Date:	14	Scale:	1:50@A0, 1:200@A4	Drawn by:	
Bourne Estate South for Higgins Construction PLC					
Drawing title: BLOCK 1 Basement Plan					
Reference:	BE14	Draw No:	219	Rev:	A

Date:	15.03.14	Scale:	1:50@A0, 1:200@A4	Drawn by:	
Project:	Bourne Estate South for Higgins Construction PLC				
Drawing title:	BLOCK 1 Ground Floor Plan				
Reference:	BE4	Draw No:	220	Rev:	A

PROJECT: Bourne Estate South for Higgins Construction PLC

Project
BOURNE ESTATE SOUTH REGENERATION

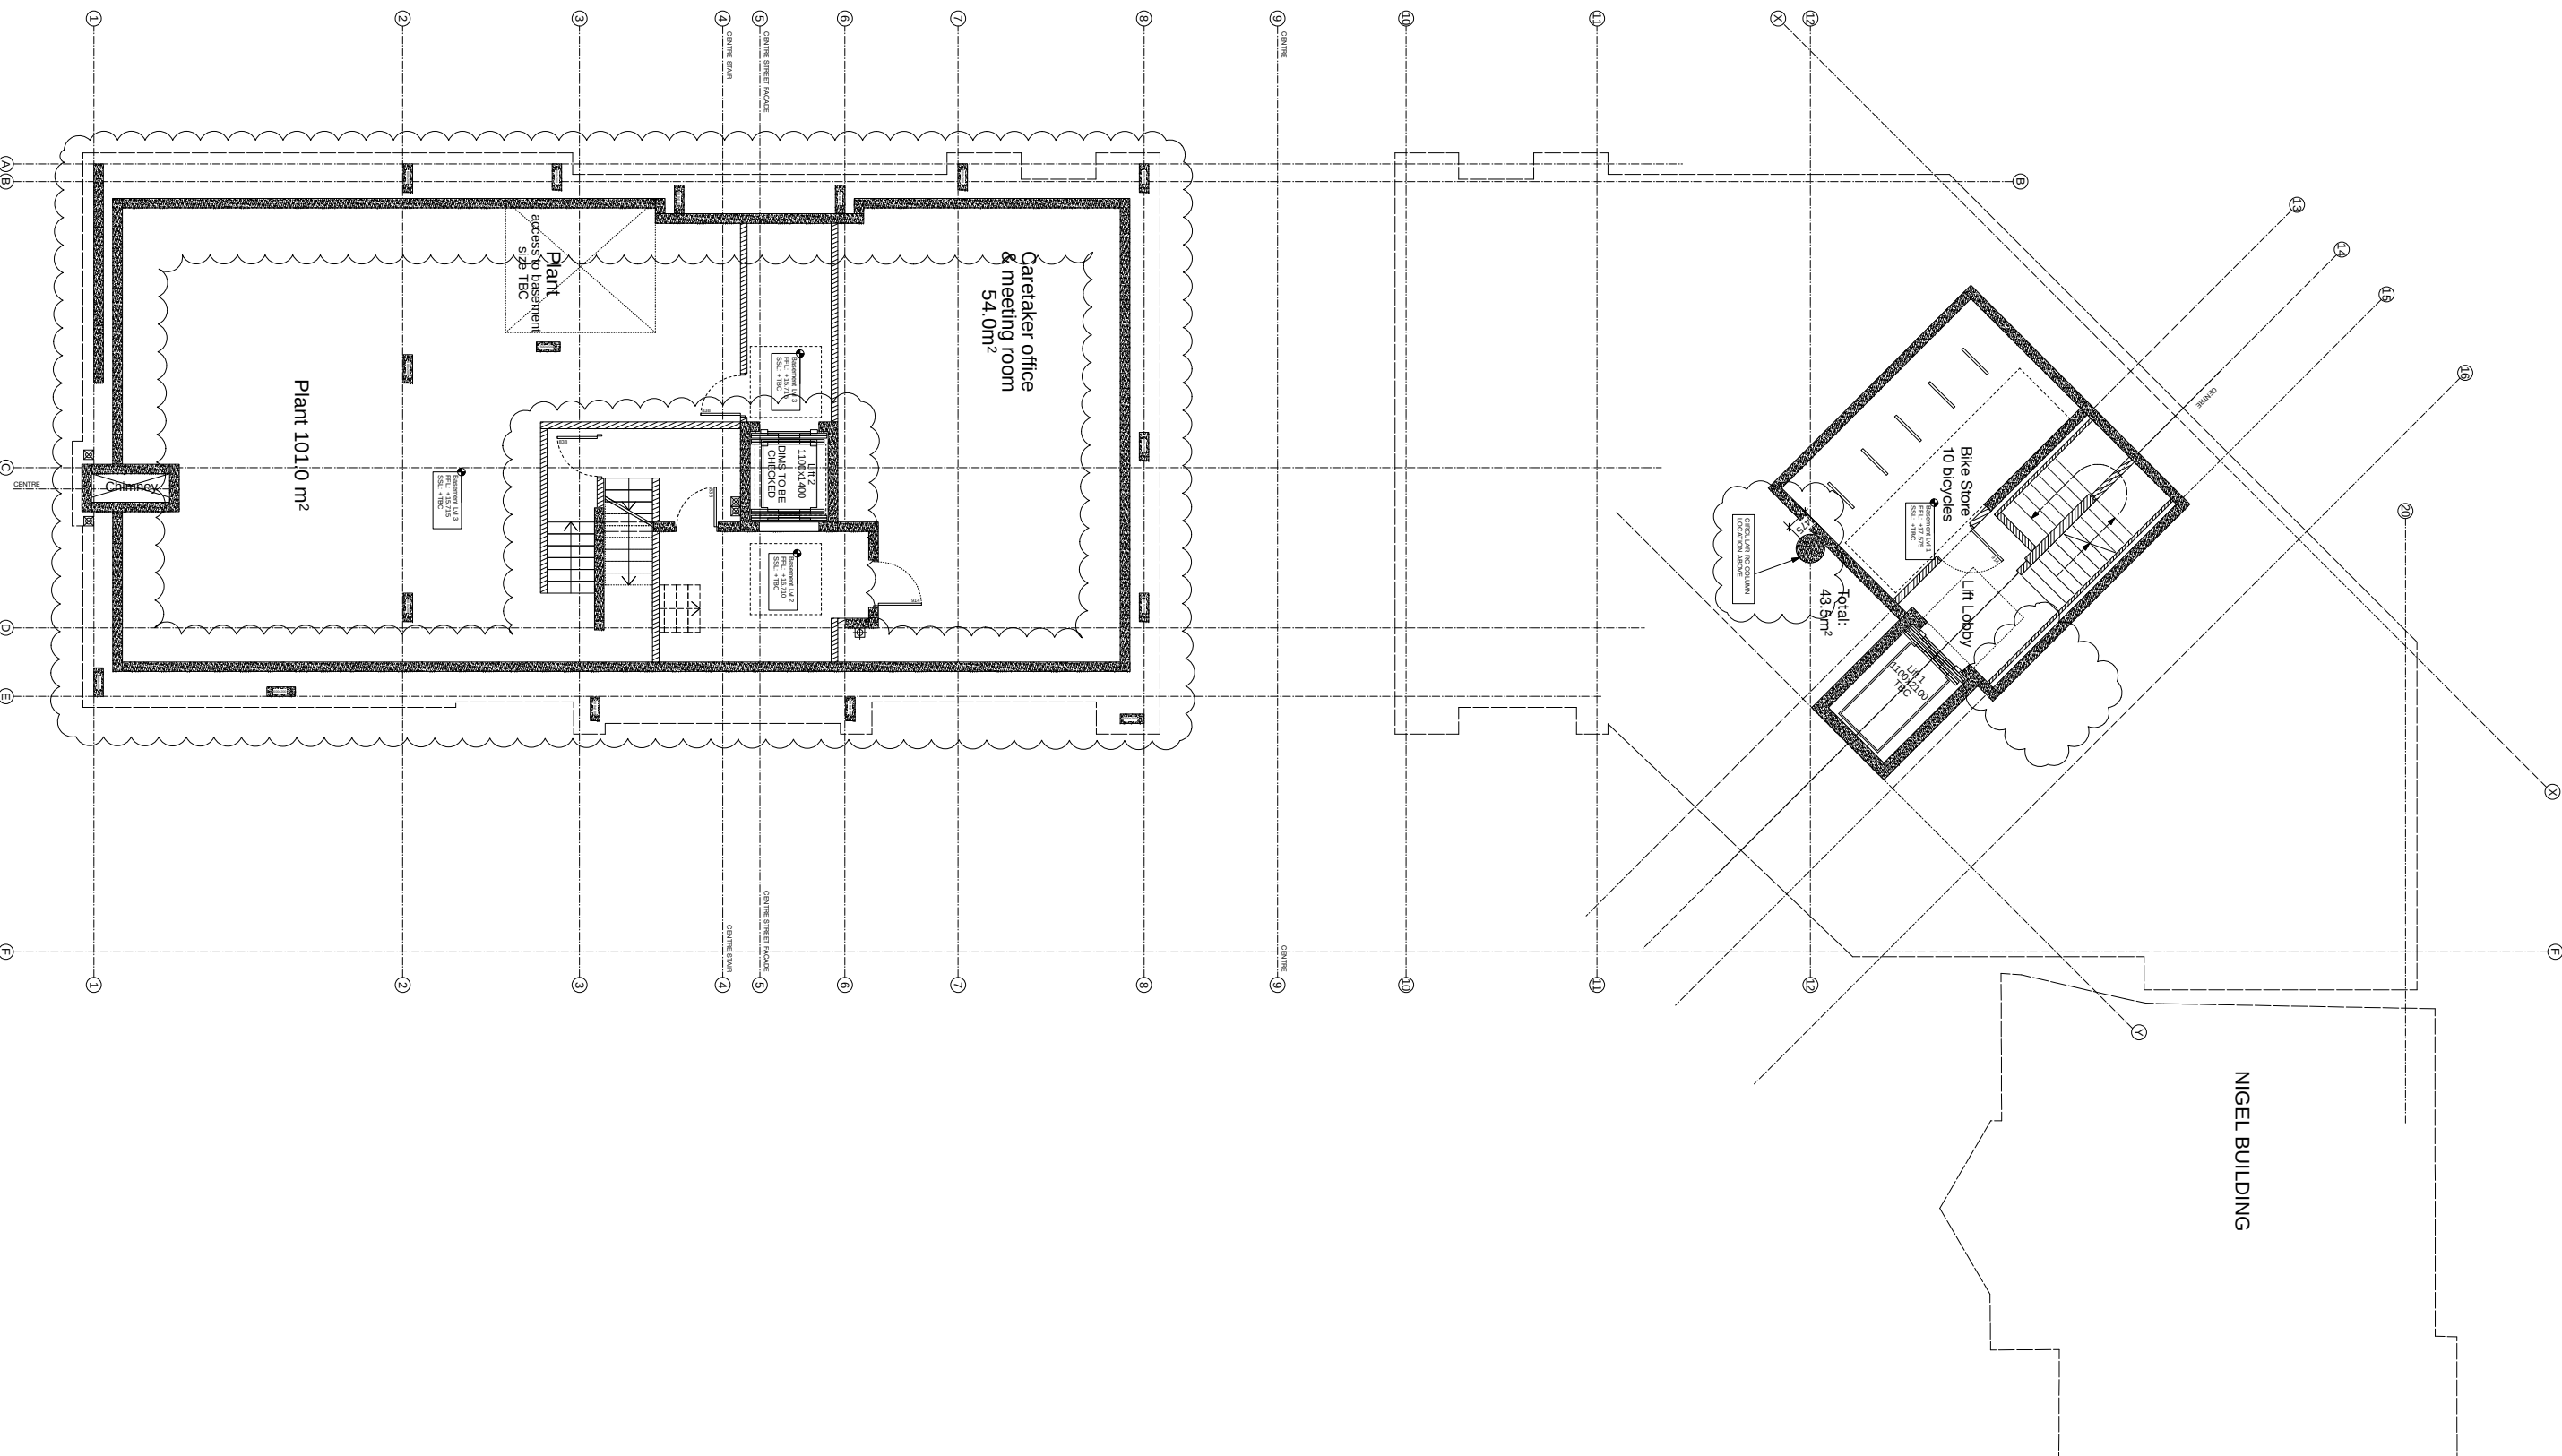
A - 20.05.14 - Basement 1: shape revised for buildability, stairs removed, Circular columns incorporated in basement wall

Basement 2 & 3: layouts revised to reflect steel & changes above, walls moved inwards to avoid pile caps

* Lightwells removed to basement

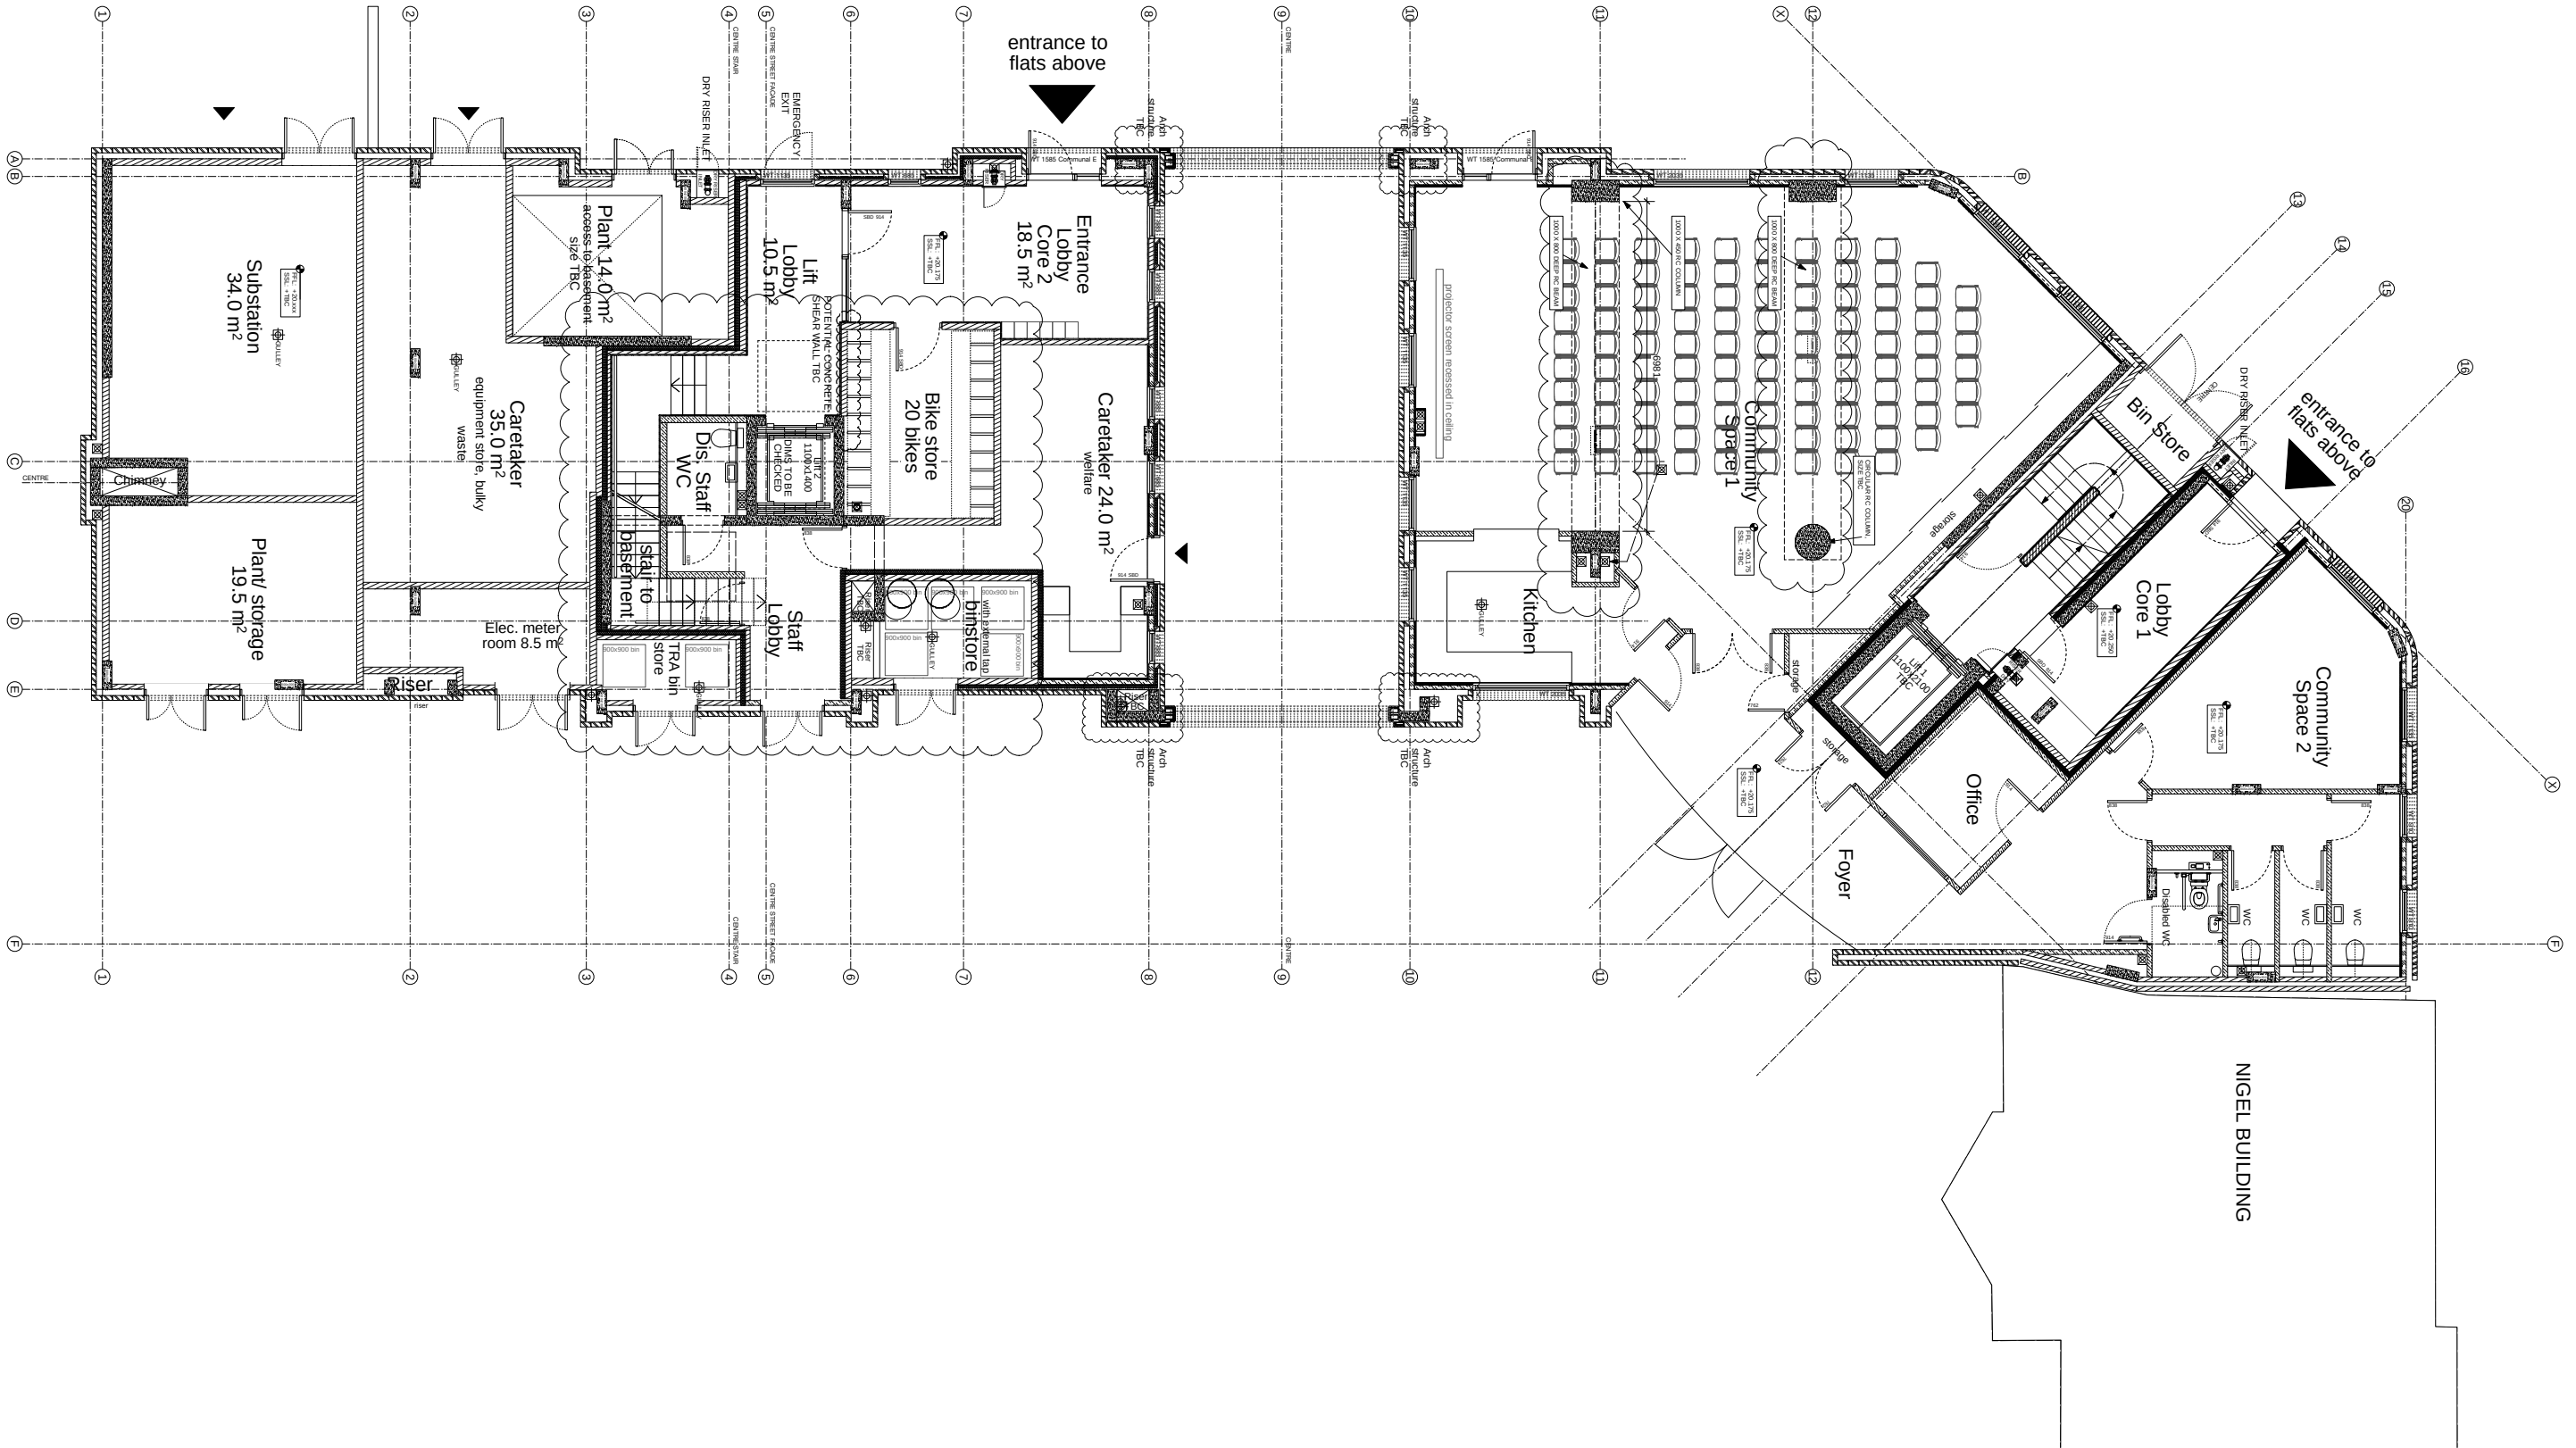
A - 20.05.14 - Columns and shear walls added
- Columns and beams added to community space
- Ground floor lobby, bike store & caretaker space amended following Core 2 change to internal lift and stairs
- Bin stores amended due to revised chute location

DRAWING: BLOCK 1 First Floor Plan

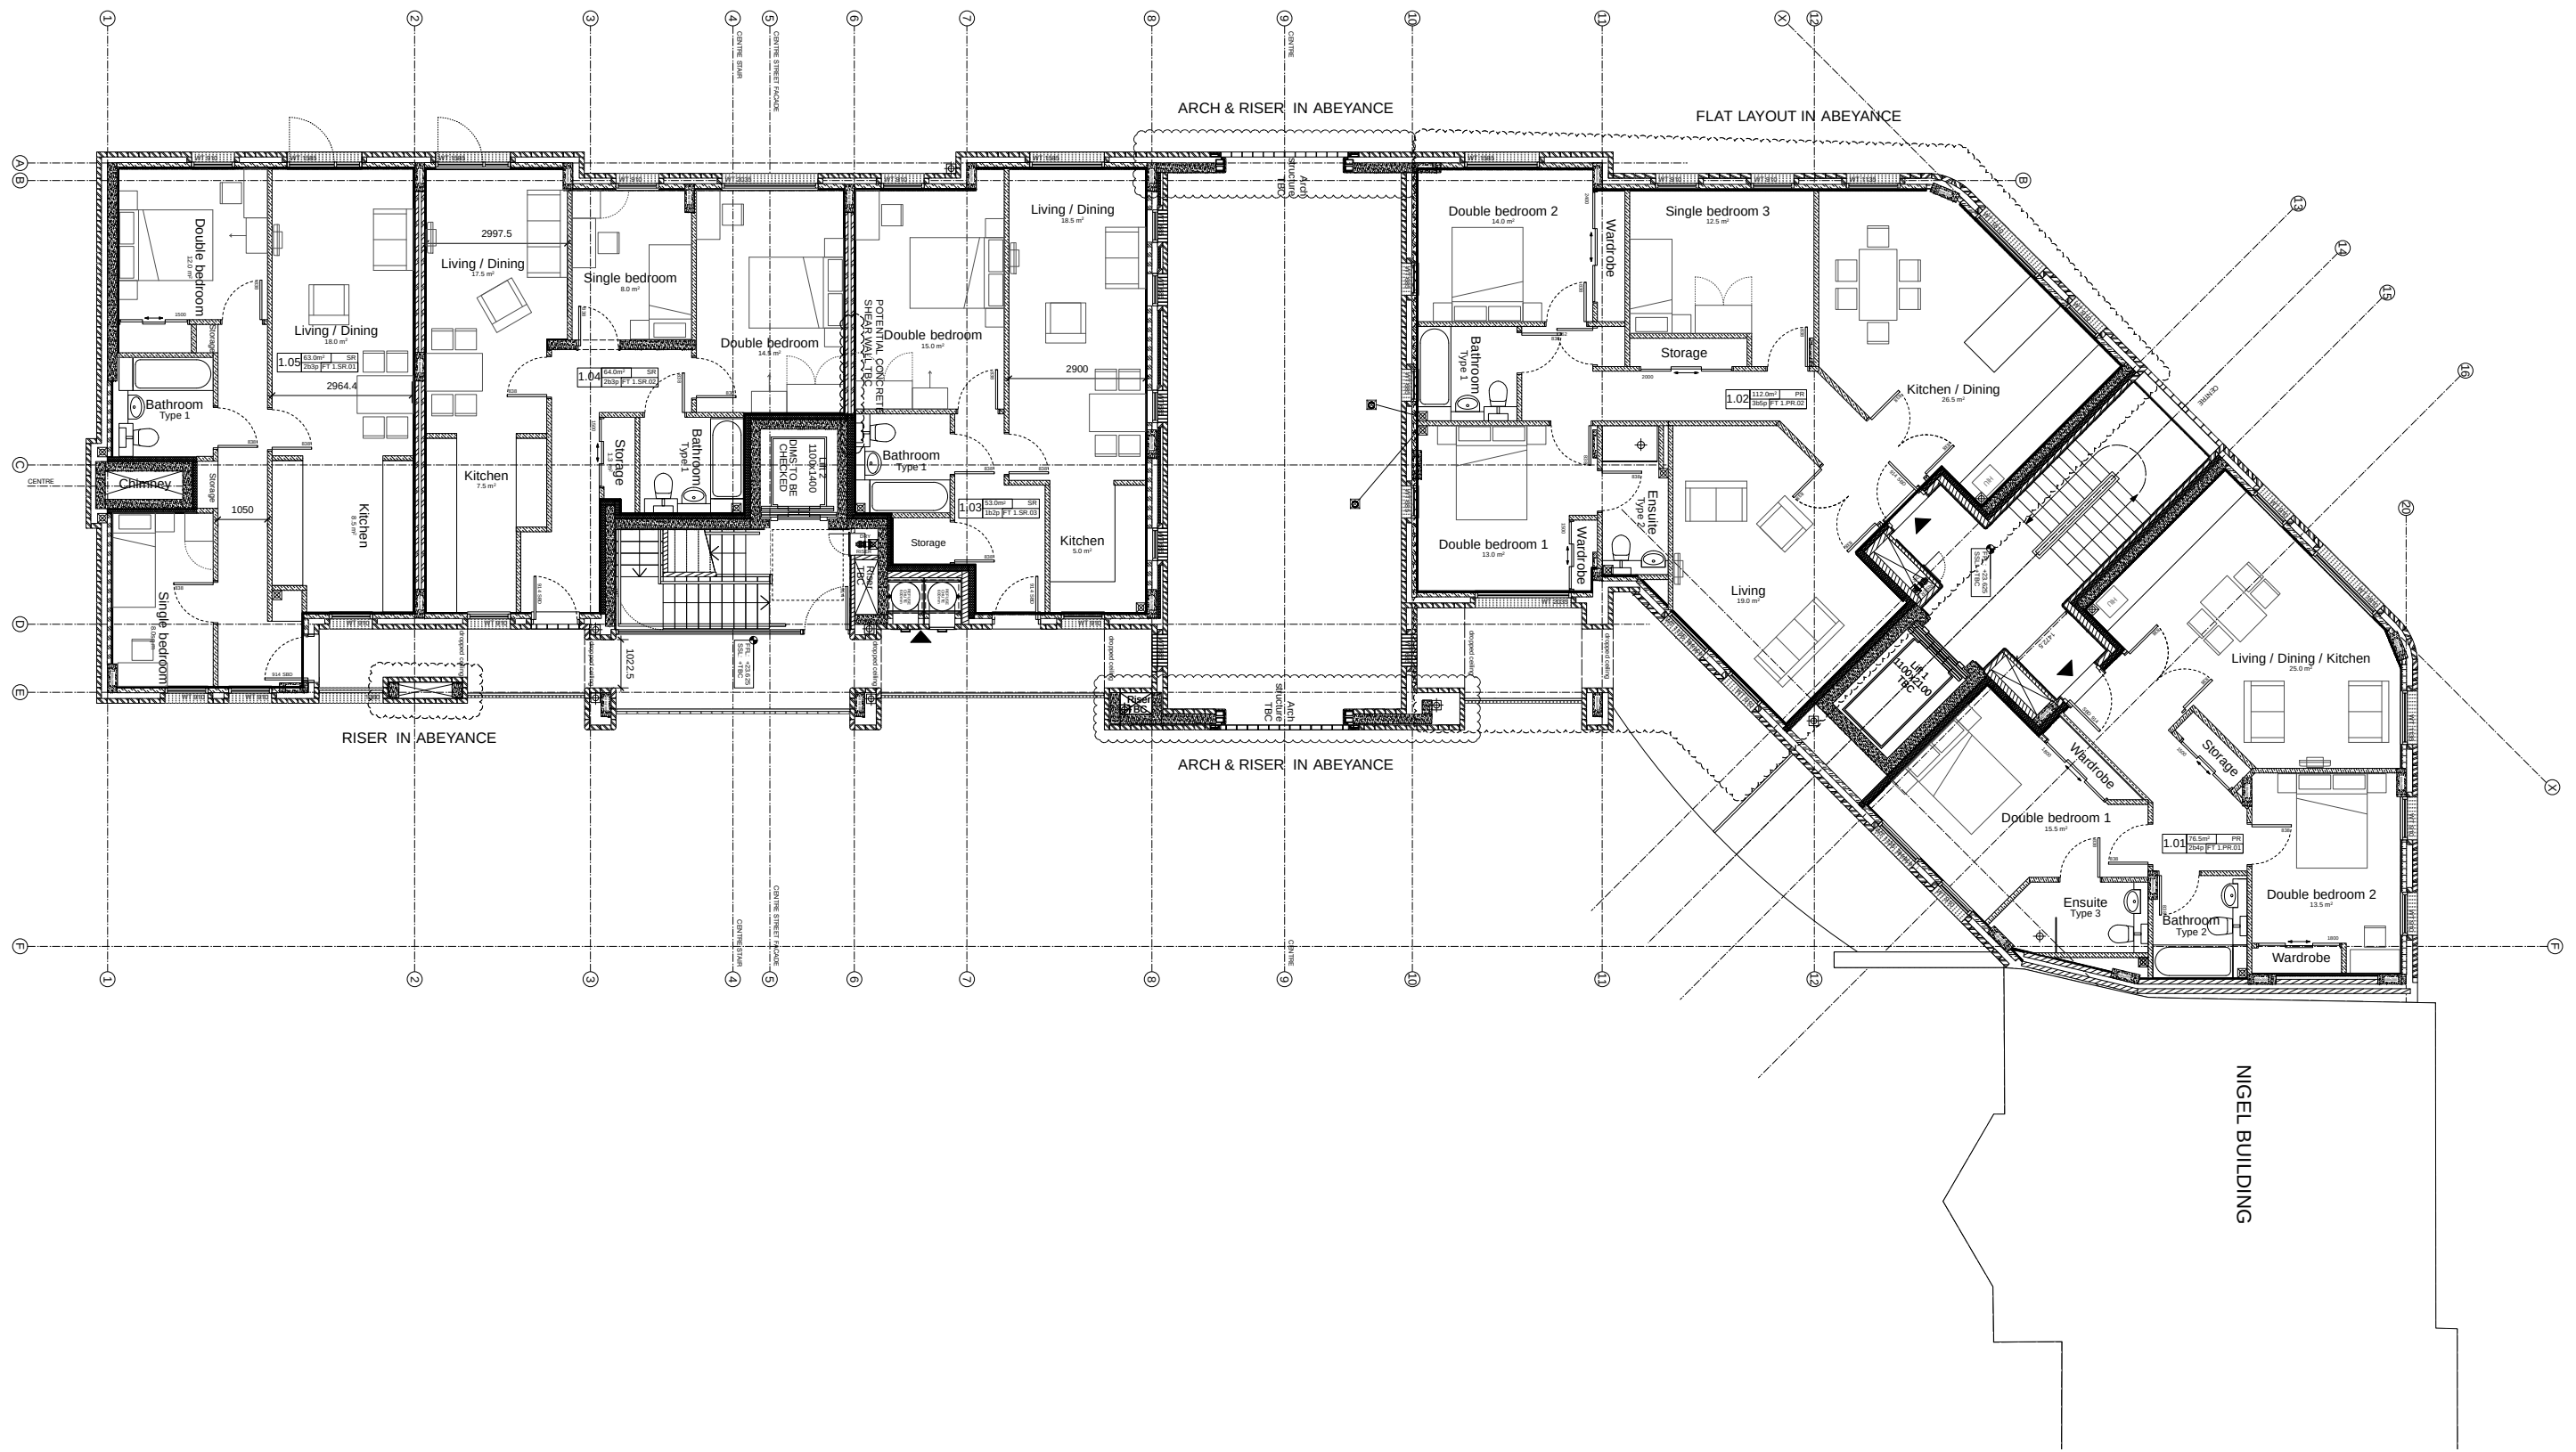
1	20.05.14 - Columns and shear walls added
2	Core B amended to have internal lift and stairs, glazed screen & glazed door added
3	Gates on deck omitted (Core B)
4	Relieve chair locations moved
5	HU cupboards moved to the inside, external HU doors and deep reveals to flat entrances (Core B) omitted
6	Kitchen window to flat 1.05 added
